Our ref: AN/2024/135560/03-L01
Your ref: EN010130
Date: 24 October 2024

Application by GT R4 Limited (trading as Outer Dowsing Offshore Wind) for an order granting development consent for the Outer Dowsing Offshore Wind Project (Generating station and transmission infrastructure)

1.0 Draft Development Consent Order [PD1-024]

- 2. Overview Plan** The comments relate to the access routes alongside the River Welland, shown in the image below:

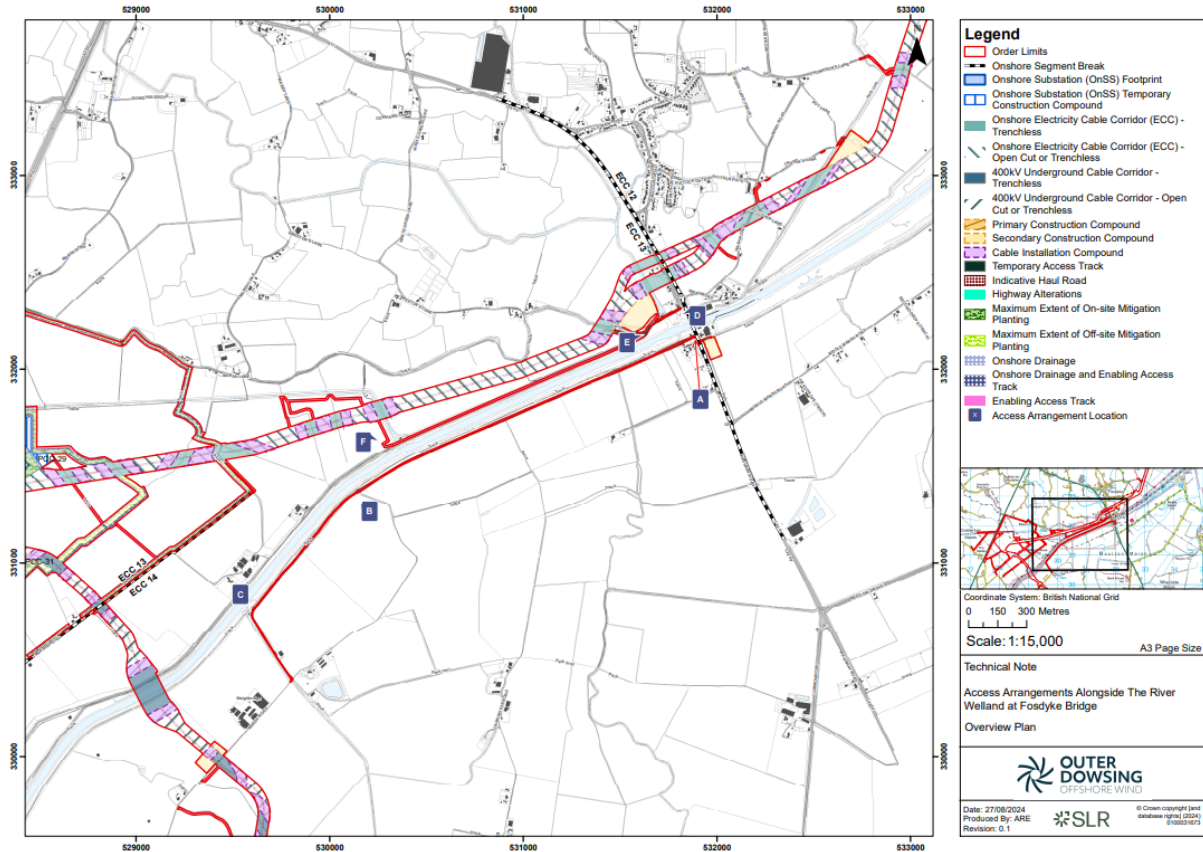
- 1. Introduction** The EA has made the following comment within its ‘Relevant Representation’ requesting more information regarding the Applicant’s proposed access works alongside the River Welland:

*13.0.7 Table 24.2 (on page 28) states in response to an Environment Agency comment that “It is not intended to locate the cables within the flood defence. At its closest point, the cables would be a minimum of 40m from the flood defence upstream of Fosdyke Bridge. It is possible that this is a miss understanding of the plans, which show a temporary access track running along the flood defence”. We would like to discuss this matter with the Applicant to determine if the **location of the temporary access track, which runs along the flood defence, is appropriate**. The Applicant may need to provide evidence to demonstrate that the proposed access track would not undermine the defence.*

The Applicant has produced this document to provide the EA and IDBs with more information regarding the proposed works and use of the access tracks in close proximity to the River Welland tidal river defences.
